PARTS & SERVICE NEWS

REF NO.	AA02158A	
DATE	September 09, 2002

SUBJECT: FUEL SYSTEM IMPROVEMENT KIT

PURPOSE: To introduce to the field a new fuel system component kit for use on 12V140

FIGURE 1. FUEL SYSTEM KYT COMPONENTS

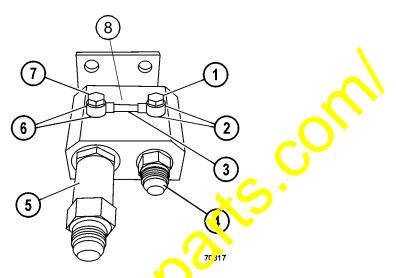
Fuel system kit (XA2088) is now available for making introvements to the fuel system on 12V140 engines. The kit contains several components for enhancing ruel system reliability. Refer to Figure 1 and the following table for kit component identification, location, and installation torques. A brief description of kit components and improvements are outlined below.

- A new fuel filter (600-311-310) has been developed which increases fuel filtration for use on 12V140 engines. It is capable of 10 micron (0.0004 in.) filtration, in addition to water separation. The new filter mounts directly to the existing filter head, and is a direct replacement for fuel filters (6216-74-6170 & V53004).
- The kit contains a creck valve that is intended to prevent the introduction of air into the fuel system. This can courit be drain back valve on the filter is opened and the fuel tank level is below filter level Air in the fuel system will result in hard starting conditions. Check valve (5, Figure 1) is to be mounted to the fuel inlet manifold and reduces the possibility of this problem from occurring.

Included in the check valve is a 300 micron filter screen that can be removed separately from the check valve for cleaning. When cleaning the filter screen, the fuel tank supply must be isolated, the supply hose removed, and the filter fitting removed from the check valve. The check valve must remain in the manifold to prevent fuel drain back from the engine.

• An additional banjo check valve (4 psi, 27.6 kPa) is included in the kit. The purpose of banjo check valve (7) is to relieve pressure from the supply side of manifold (8) to the drain side of the manifold during shutdown. The pressure relief prevents damage to fuel filter seals when normal fuel expansion occurs after shutdown. The check valve mounts on the top of the fuel manifold on the supply side. The new manifold included in the kit is equipped with ports for the installation of the new check valve, making the previous manifold obsolete.

FUEL (348 TE. KIT (XA2088)					
Reference Number	Part Number	Zescri, Con	Quantity	Installation Torque	
Not shown	600-311-3110	Fuel dilter	2	-	
1	07206-30568	Banjo Bolt	1	62 in. lbs. (7 Nm)	
2	07005-6081.	Sealing Washer	2	-	
3	6216-74-5-10	Fuel Bypass Tube	1	-	
4	6216-74-8150	Fuel Drain Fitting	1	59 ft. lbs (80 Nm)	
5	5216-74-5530	Fuel Supply Fitting (Check Valve)	1	59 ft. lbs (80 Nm)	
6	07005-01012	Sealing Washer	2	-	
7	6216-74-5540	Banjo Check Valve	1	97 in. lbs. (11 Nm)	
8	6216-74-5420	Fuel Inlet Manifold	1	-
